Access Compliance Report

Public Rights-of-Way

(Curb Ramps)

Intersection ID: 15201	Main Street: ALBEMARLE_RD	Cross Street: LAWYERS_RD	Location: S
ADA ID: 6939FCD0FDDE	Ramp Type: IslandPerp	Initial Pass/Fail: Fail	Overall Compliance: No
Severity Score: 33.75			
Codes/Mitigation Info/Possible Solution		Field Measurements/Component Compliance

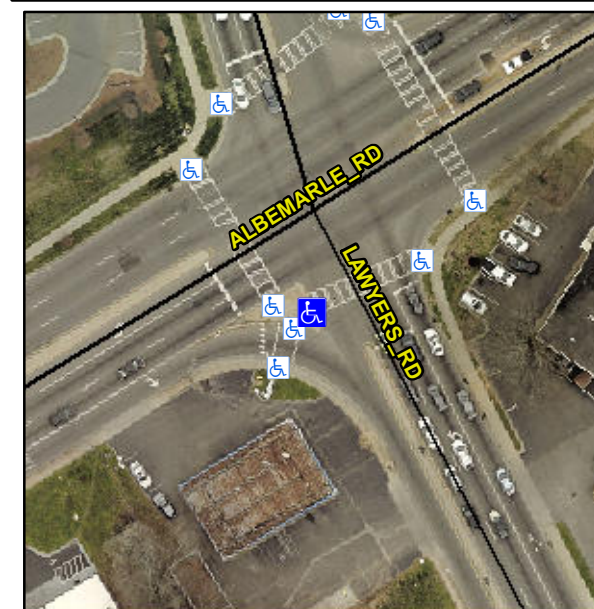
R304.5.1, R304.2.2, R304.5.3

Compliance	Description	Data	Compliance	Description	Data
N/A	Ramp Length (in)	60.0	No	Ramp Slope (%)	9.4
No	Ramp Width (in)	46.0	No	Ramp XSlope (%)	6.0
N/A	Flare Type LT	N/A	N/A	Flare Type RT	N/A
N/A	Flare Slope LT (%)	N/A	N/A	Flare Slope RT (%)	N/A
N/A	Flare Traversable LT?	N/A	N/A	Flare Traversable RT?	N/A
N/A	Landing Length (in)	N/A	N/A	DWS Provided?	N/A
N/A	Landing Width (in)	N/A	N/A	DWS Contrast?	N/A
N/A	Landing Slope (%)	N/A	N/A	DWS Length (in)	N/A
N/A	Landing X Slope (%)	N/A	N/A	DWS Full Width?	N/A
N/A	Landing Curb? (Y/N)	N/A	N/A	DWS Offset (in)	N/A
N/A	Shared Landing?	N/A			
N/A	Gutter Ponding?	N/A	N/A	Gutter Slope (%)	N/A
N/A	Gutter Lip Ht (in)	N/A	N/A	Gutter X Slope (%)	N/A
N/A	Painted X Walk1?	Yes	N/A	Painted X Walk2?	N/A
	X Walk 1 Direction	To E		X Walk 2 Direction	N/A
N/A	X Walk 1 Width (in)	127.0	N/A	X Walk 2 Width (in)	N/A
	X Walk 1 Slope (%)	1.4		X Walk 2 Slope (%)	N/A
	X Walk 1 X Slope (%)	3.6		X Walk 2 X Slope (%)	N/A

Remove & Replace Entire Ramp.
